ADDENDUM NO. 1

LIFT STATION 23 IMPROVEMENTS

LACEY CONTRACT NO. PW 2022-12

CITY OF LACEY, WASHINGTON			
DEPT. OF PUBLIC WORKS			
4" THRU 8"			
PIG LAUNCH ASSEMBLY			
APPROVED		DWG. NO.	
<i>Ryan A. Schmitt</i>		7-21.0	
CITY ENGINEER			
DES. WHO	DWN. WHO	CKD. RAS	DATE 08/24/2017

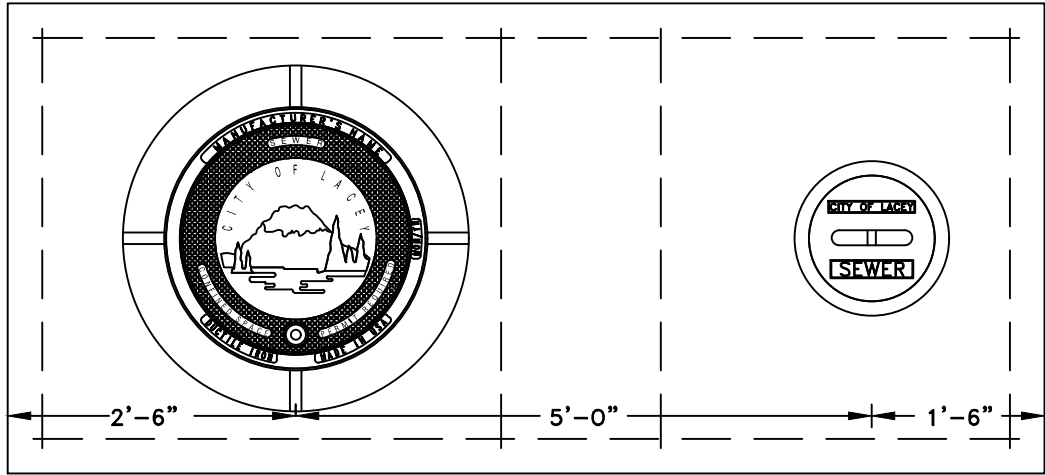
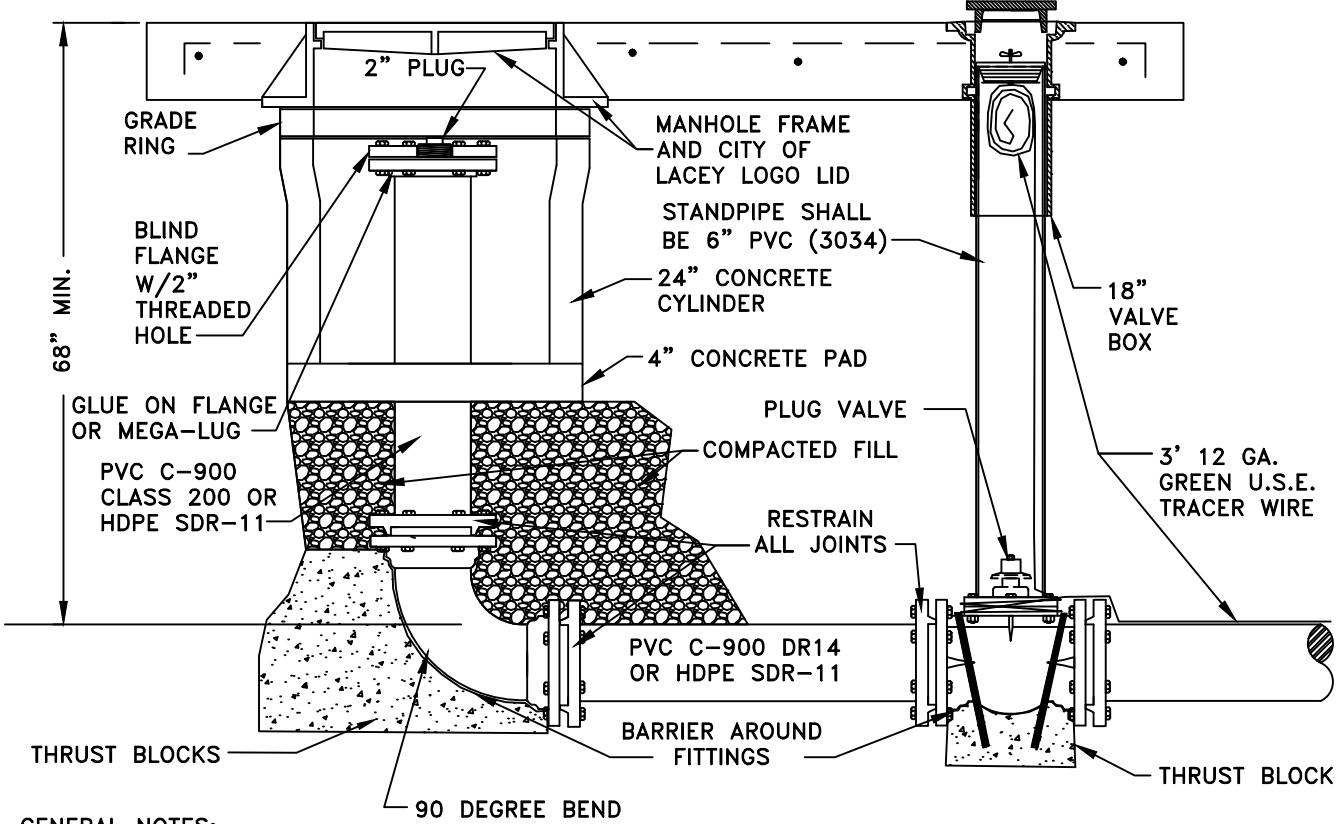
Add the attached detail DWG 7-21 (4" thru 8" Pig Launch Assembly) as a reference to the plans.
